umweltbundesamt^U
ENVIRONMENT AGENCY AUSTRIA

NPP Paks II

**Paleoseismological assessment of the Siting Report
and the Site License with respect to fault capability**

Figure: Geological Site Report, Acs et al., 2016, Fig. 420

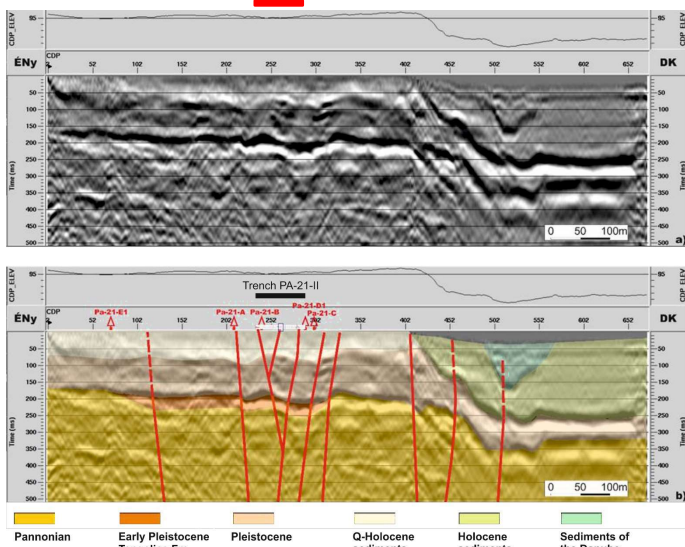
Seismic profile Pa-21-S across part of the DHFZ (700 m SE of the existing NPP Paks)

The profile shows 10 individual faults (indicated by the red lines) that offset even the youngest sediments of the Danube. These faults are shown to reach up to the surface.

Figure: Geological Site Report, Hálász et al., 2016, Fig. 11 and 12

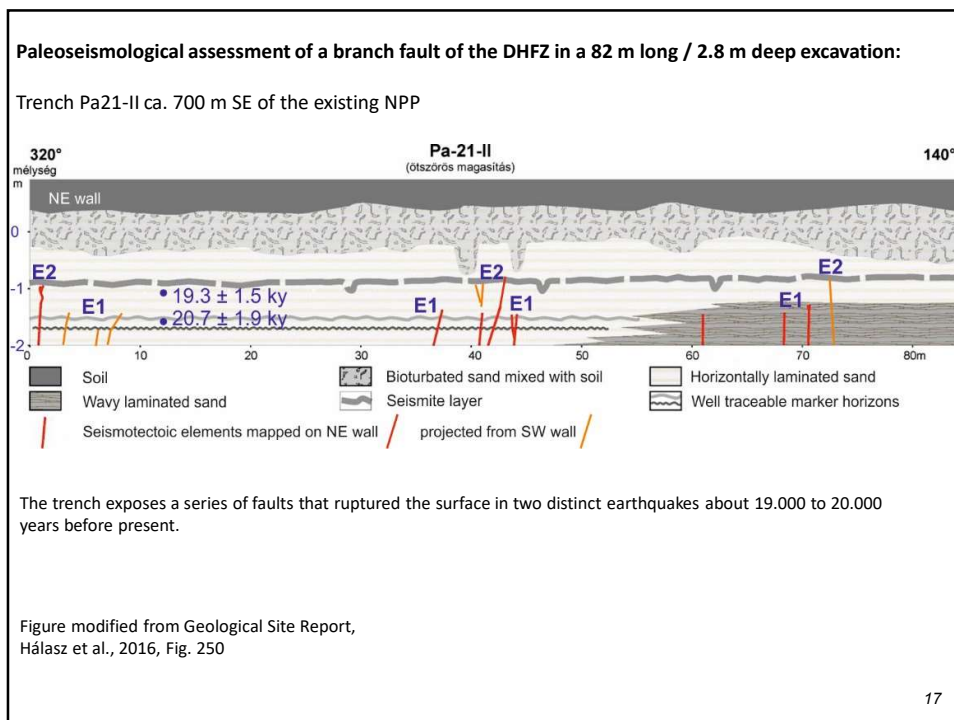
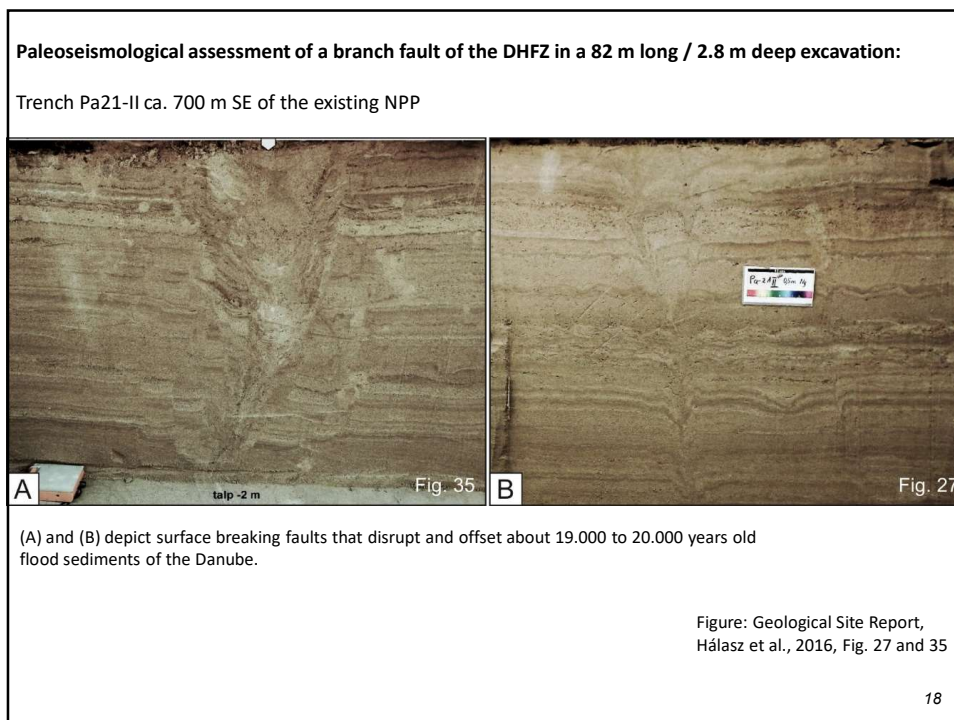
Paleoseismological assessment of a branch fault of the DHFZ in a 82 m long / 2.8 m deep excavation:

Trench Pa21-II ca. 700 m SE of the existing NPP

Figure: Geological Site Report, Hálasz et al., 2016, Fig. 27 and 35

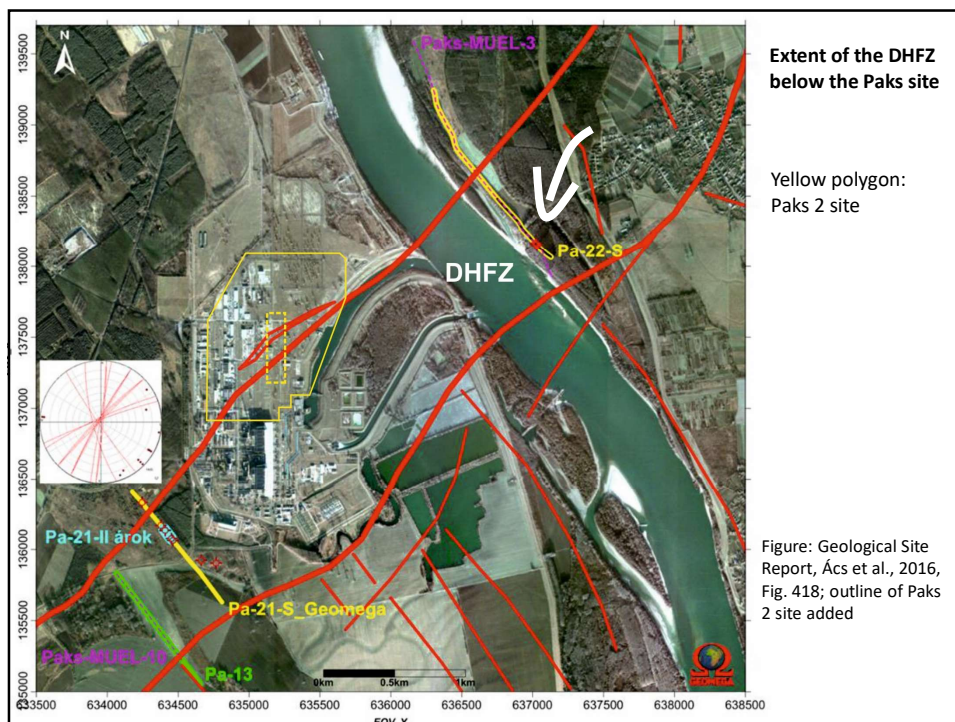
Paleoseismological assessment of a branch fault of the DHFZ in a 82 m long / 2.8 m deep excavation:

Trench Pa21-II ca. 700 m SE of the existing NPP

(A) depicts a surface breaking fault that disrupts and offsets about 19.000 to 20.000 years old flood sediments of the Danube.
